LOCAL TRAFFIC COMMITTEE MEETING

Venue	Conference Room, Station Street, Mullumbimby
Date	Tuesday, 17 August 2021
Time	10.30am
Committee Members	Penny Sutton – Transport for NSW Detective Chief Inspector Matt Kehoe – Police Cr Basil Cameron Tamara Smith MP

REPORT OF THE LOCAL TRAFFIC COMMITTEE MEETING HELD ON TUESDAY, 17 AUGUST 2021

Report No. 6.1 Lilium Love Cafe, Huonbrook Rd (No Stopping)
File No: I2021/1001

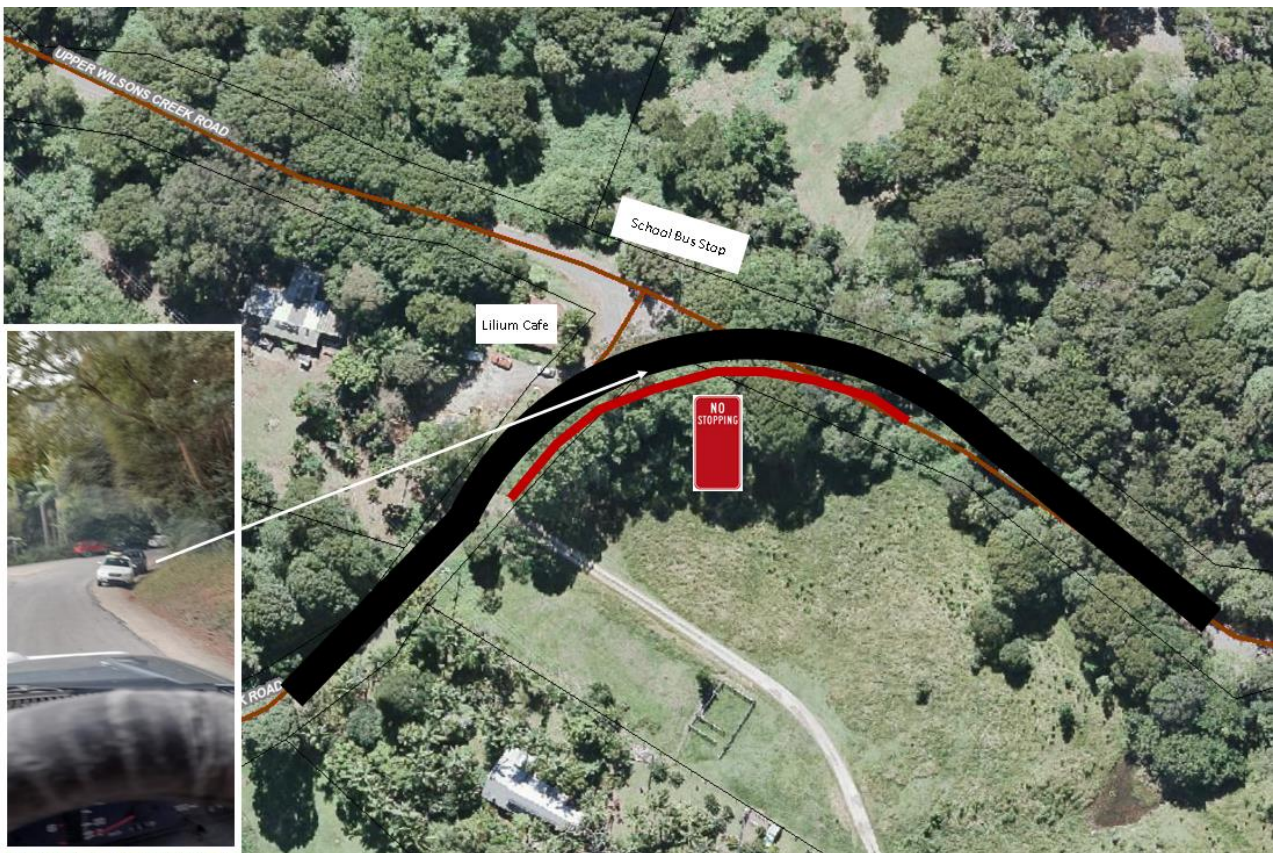
Therefore, staff propose to install No Stopping signs along the inside curve of Hounbrook Road / Wilson Creek Rd intersection.

Note the situation of conflicted bus zone safety issues are replicated in multiple locations on hinterland road network and serious safety issues detailed in recent Council survey feedback on provision of bus stops and zones. There is a disconnect between funding for DDA 'compliant' bus stops and the fact that the majority of bus patrons do not use these sites and remain largely unprotected at drop off and pick locations along routes.

- 1. That Council supports the installation of No Stopping signs along the inside curve of Hounbrook Road / Wilson Creek Rd intersection for approximately 50m either side of the intersection.**
- 2. That Council considers advisory signs for bus stop/routes ahead to improve safety for bus passenger along Hinterland roads.**

Report No. 6.2	Car share - request from provider Popcar for four additional designated parking bays
File No:	I2021/726

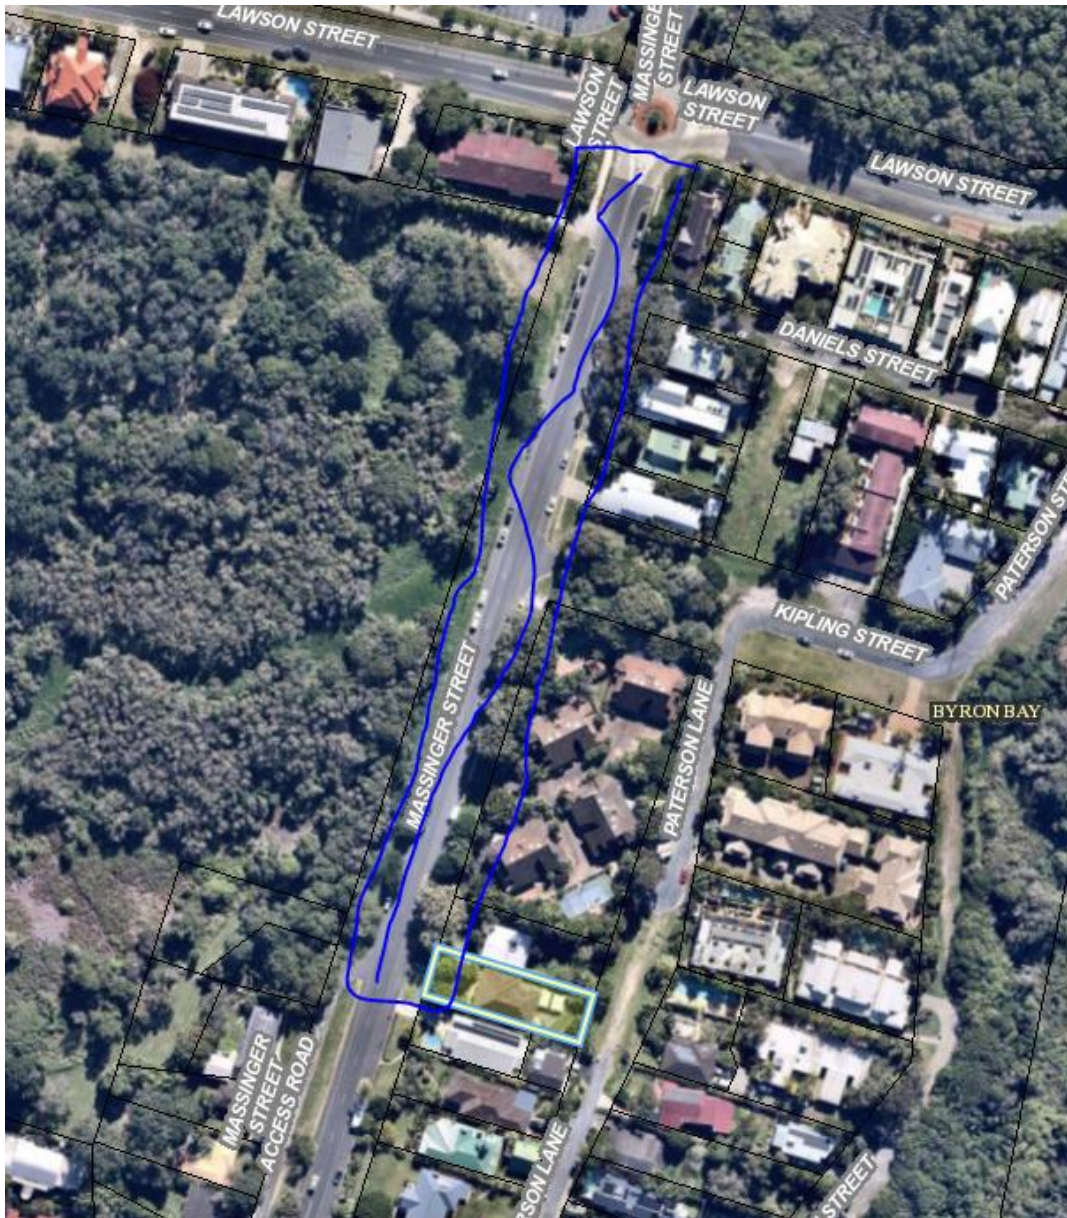
Copy of the plans to be provided to members before installation of any signs.

Recommendations to include regulatory signage

1. That LTC support the car share service 'Popcar', to lease four additional designated parking bays in Byron Bay at the following locations:

- a) 24 Shirley Street**
- b) 122 Jonson Street**
- c) 39 Lawson Street**
- d) 1 Massinger Street**

2. That Council includes installation of regulatory signage in accordance with TfNSW Guidance for on street fixed space car share parking.

Report No. 6.4 Event application - Compass Club East Marathon - Byron Bay
File No: I2021/1168

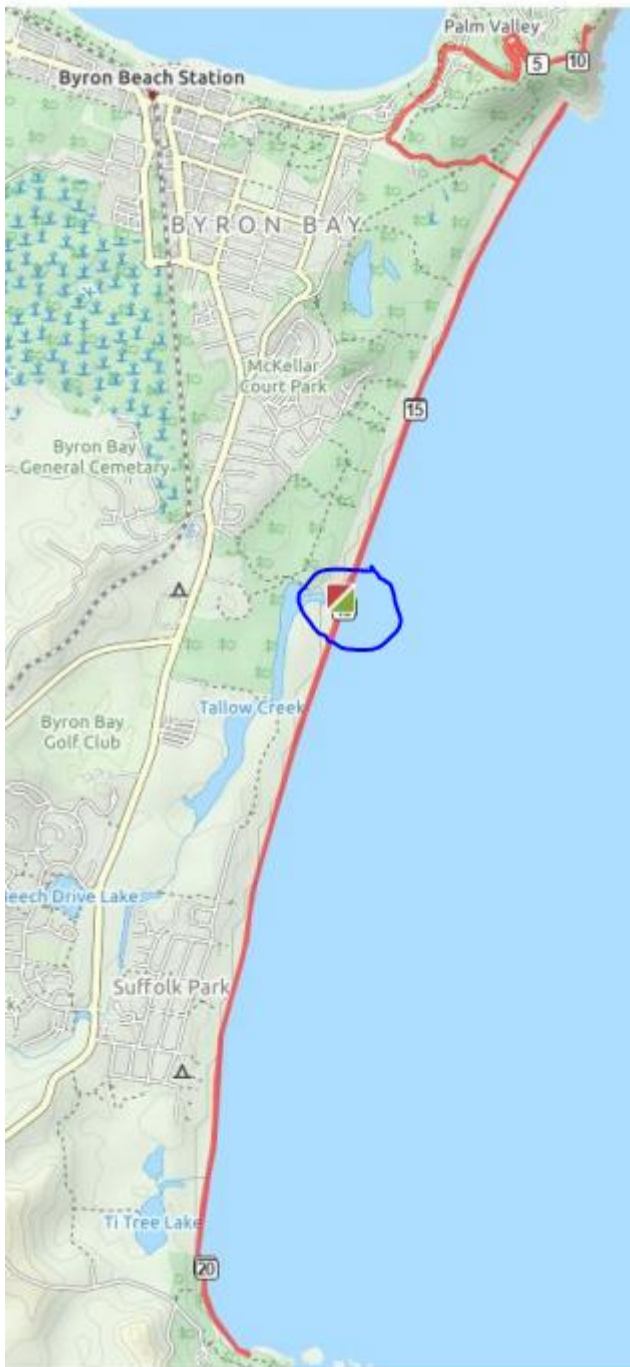
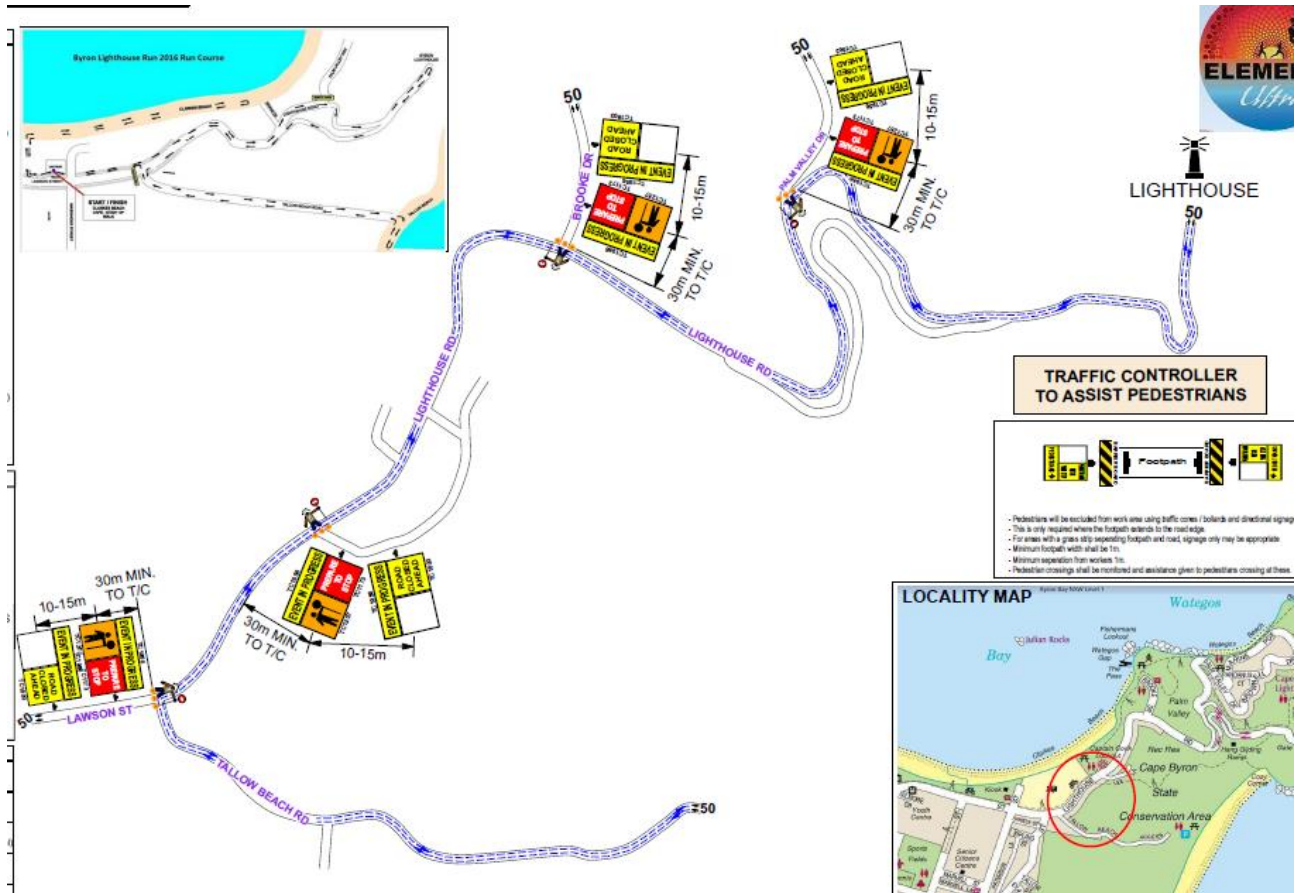
Police: Residents should be able to access Wategos, the Pass etc. Not supporting total closure of Lighthouse Road.

TfNSW: devices that organisers want to implement to be approved

Committee to receive: Detailed plans with regulatory signages, COVID-19 plans, full traffic management plan

This report to be deferred to the next extraordinary meeting of LTC in October after receiving detailed plans from organisers.

Original approved location

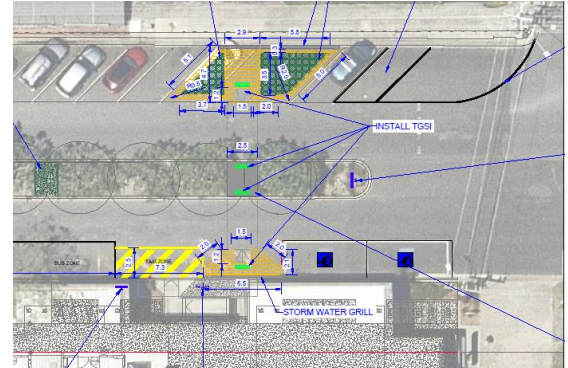
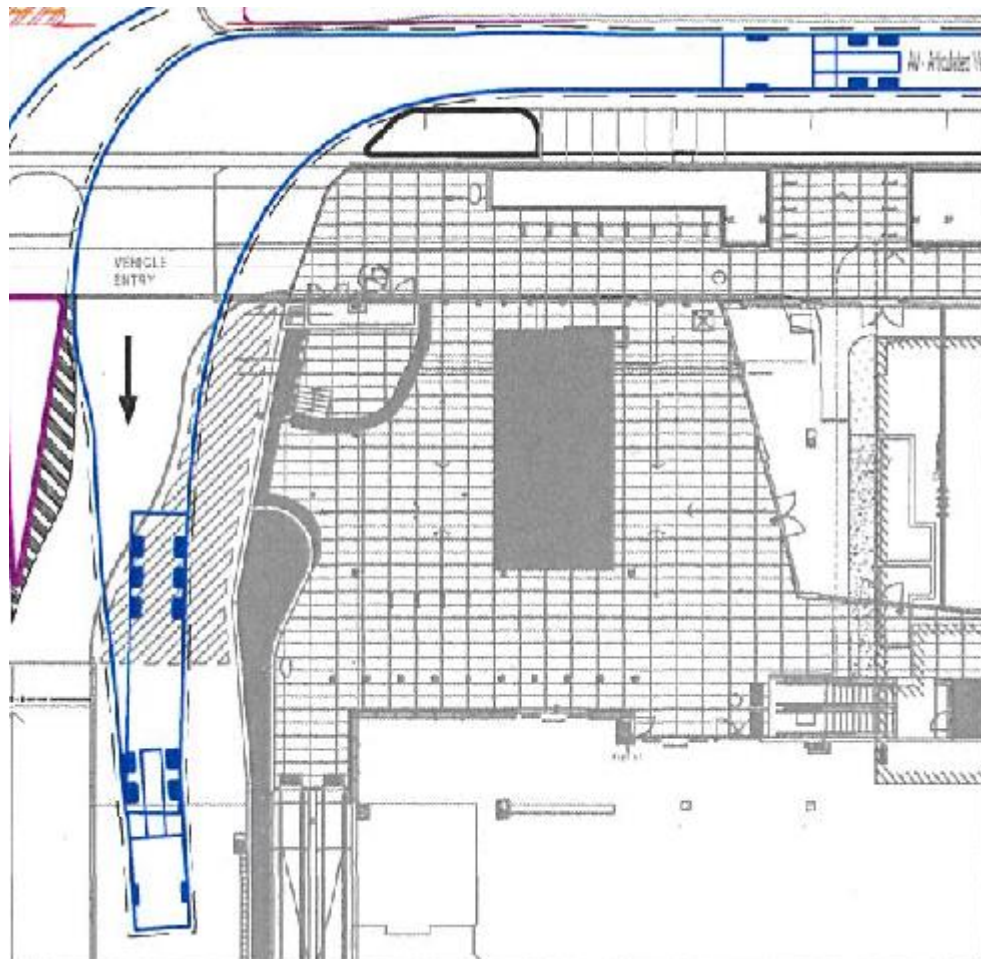
This is situated near the development access (see above). This location will reduce the angle parking supply by a maximum of 3 parking spaces on the east side of Jonson St and no reduction of parking spaces west of Jonson St. A net parking supply reduction of three (3).

The proposed location is situated near Kingsley St intersection (see above). The proposal will involve the removal of one taxi rank space to accommodate a ramp down for pedestrians to cross the street. The works will also involve a ramp on the other side of the street with complimenting landscaping, new line marking and the relocation of one car space to make room for the pedestrian ramp across the road.

The proposal offers more details than the approved location however the proposal will provide a greater impact to the supply of the existing taxi ranks adjacent the development and parking.

The proposal also offers to relocate one angle car space close to Kingsley St intersection. This proposal does meet the no-stopping distance space requirement near a priority intersection (minimum 10m). The net parking supply reduction are three (3) angle parking and one (1) taxi rank. No justification provided why the reduction of one (1) taxi rank is acceptable.

This location also provides a longer travel path from the main entrance of Mercato to travel approximately forty (40m) minimum along the frontage of the development.

The comparison based on the criteria above found that the originally approved location in DA10.2013.587.1 will provide a more suitable location than the new proposal.

It is recommended that the new proposal is not supported and the adoption of the approved location in DA10.2013.587.1 be endorsed.

- 2. That LTC be provided with updated plans and details including pedestrian facility in original approved location, bus stop, taxi rank, motorcycle parking with relation to regulatory signage for consideration and recommendations for approval at the next LTC meeting.**
- 3. That a priority with supporting signage is established to the crossover to pedestrians and cyclists.**
